From: Phil Koen
Sent: Sunday, August 30, 2020 12:21 PM
To: Matt Morley <MMorley@losgatosca.gov>
Cc: Laurel Prevetti <LPrevetti@losgatosca.gov>
Subject: Agenda item #7

In reviewing the Roadside Vegetation Management Plan, the vegetation map on page 1 of Figure 2 appears to have incorrectly identified a road that doesn't exist. I have attached the map in question. The map shows a road extending up Fairview Ave to the Town boundary. There is no roadway that extends from Fairview Ave to the Town Boundary.

No Street

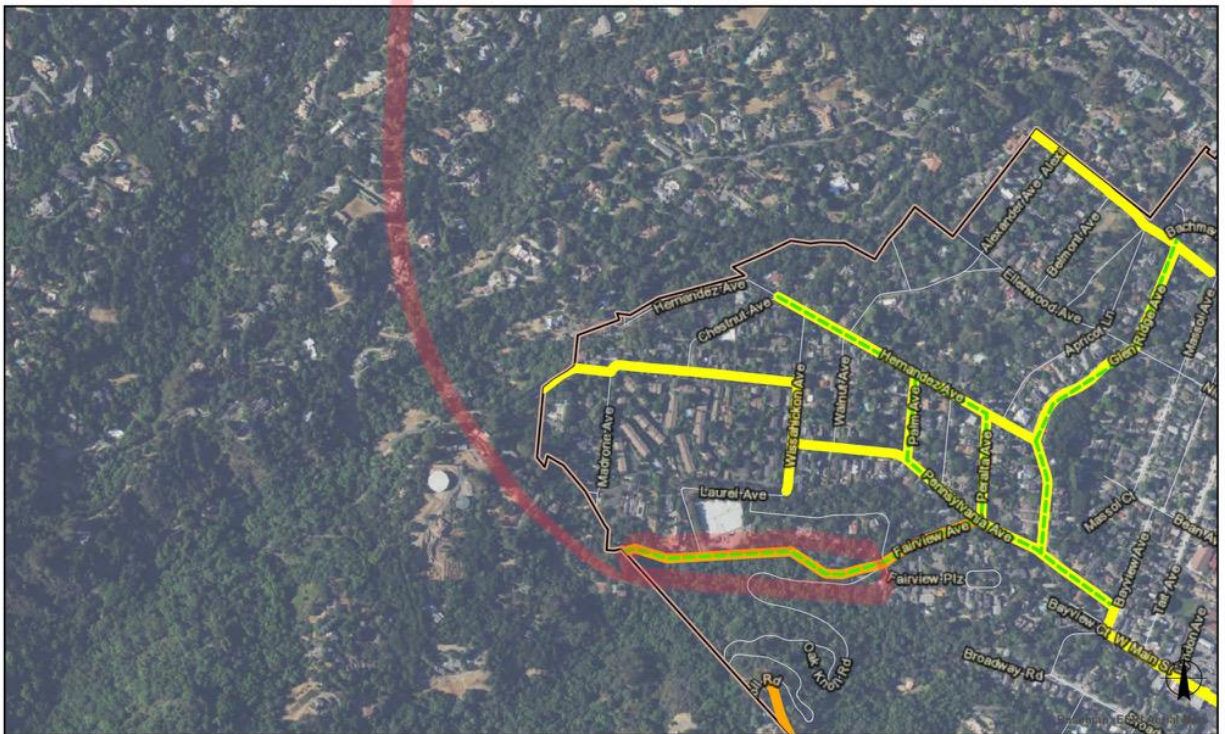
I would request that the vegetation map be corrected to reflect Wadsworth Ave and Laurel Ave as evacuation routes.

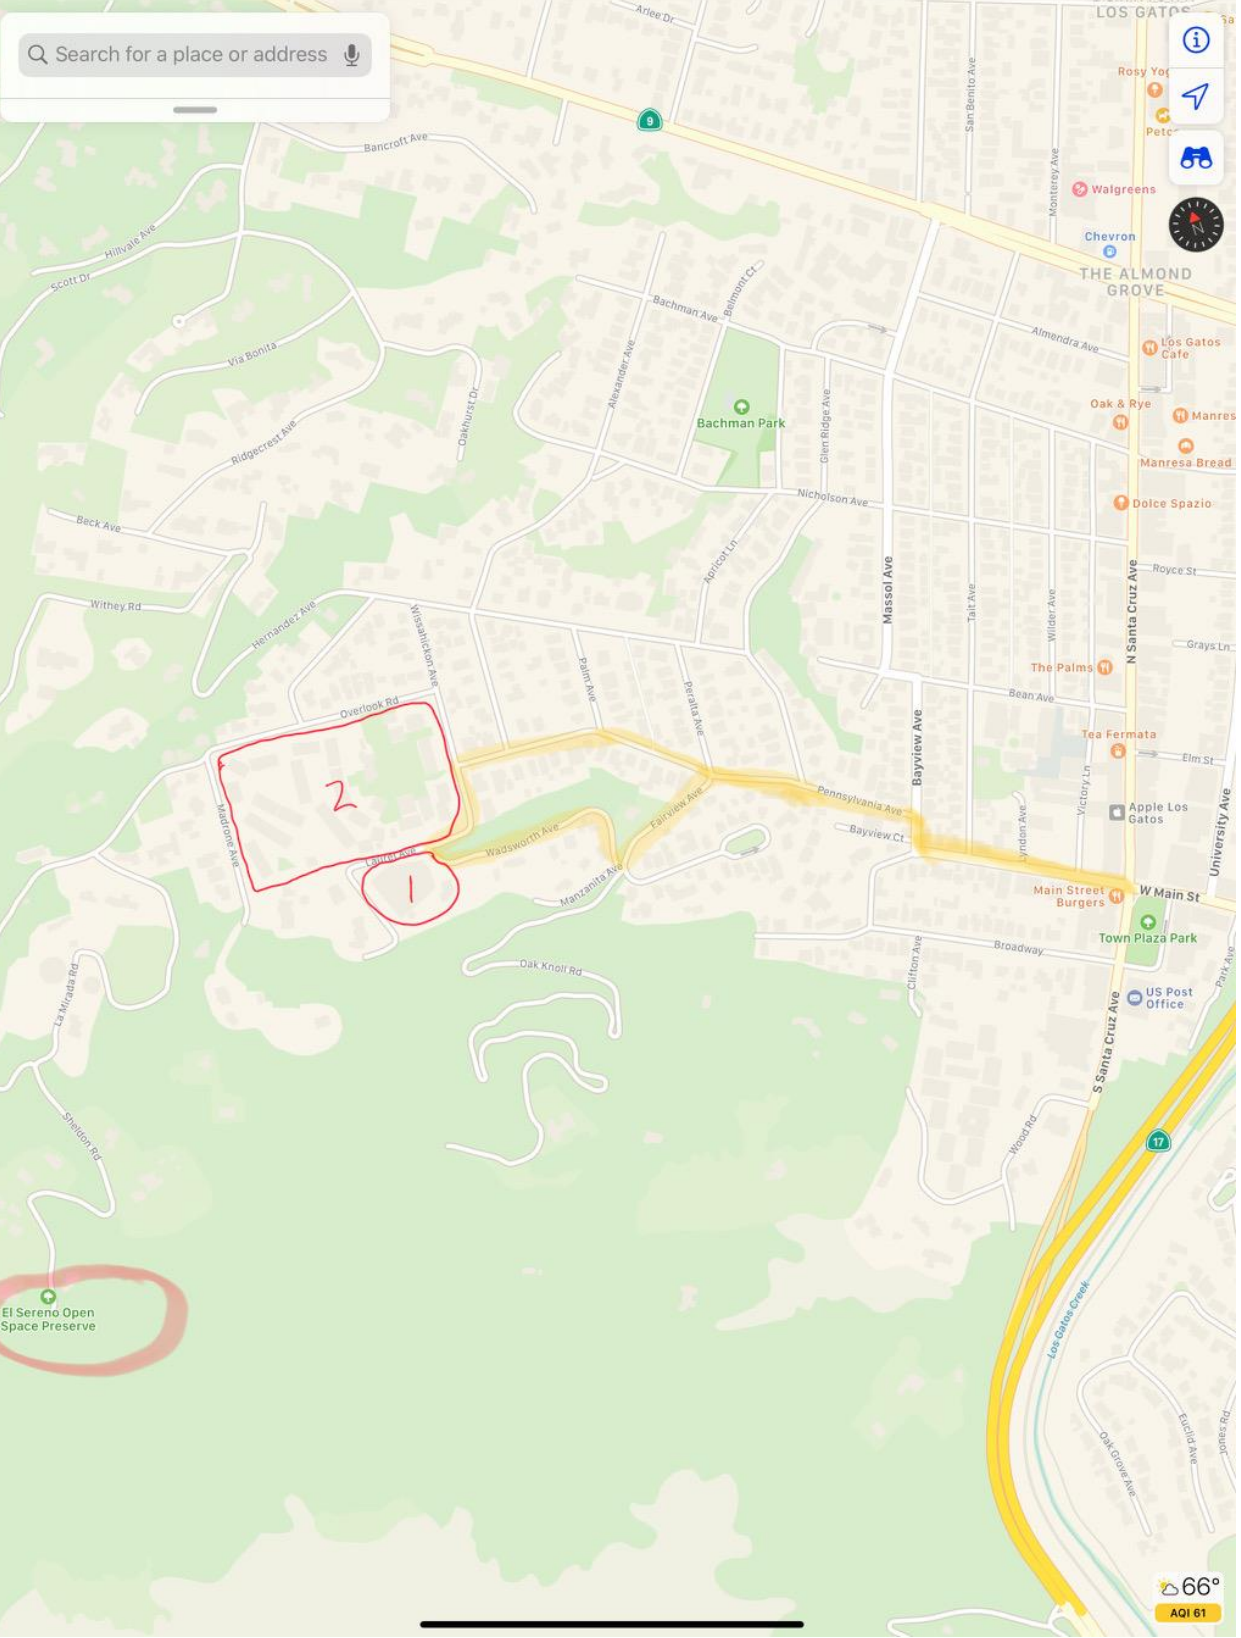
I have attached a picture of the street map for this area. As you can see Wadsworth Ave extends from Fairview Ave past San Jose Water's storage reservoir (which is critical infrastructure for the Town and is shown as #1) and then intersects Laurel Ave. Laurel Ave and Wadsworth provide a critical evacuation road for the multi-family complex (shown as #2) bordered by Laurel Ave, Wissahickon Ave, Overlook Ave and Madrone Ave.

I have also attached pictures of both Laurel Ave and Wadsworth Ave. As you can see there is extensive dense vegetation with considerable overhead growth. Given that both Laurel Ave and Wadsworth Ave are roads that serve as evacuation routes for the multi-family complex and as well as a fire emergency access road to protect the water reservoir and the multi-family complex, I believe that these roads should be designated as VMAL priority level 1. They certainly meet the criteria outlined in the Vegetation Management Plan for priority level 1 designation.
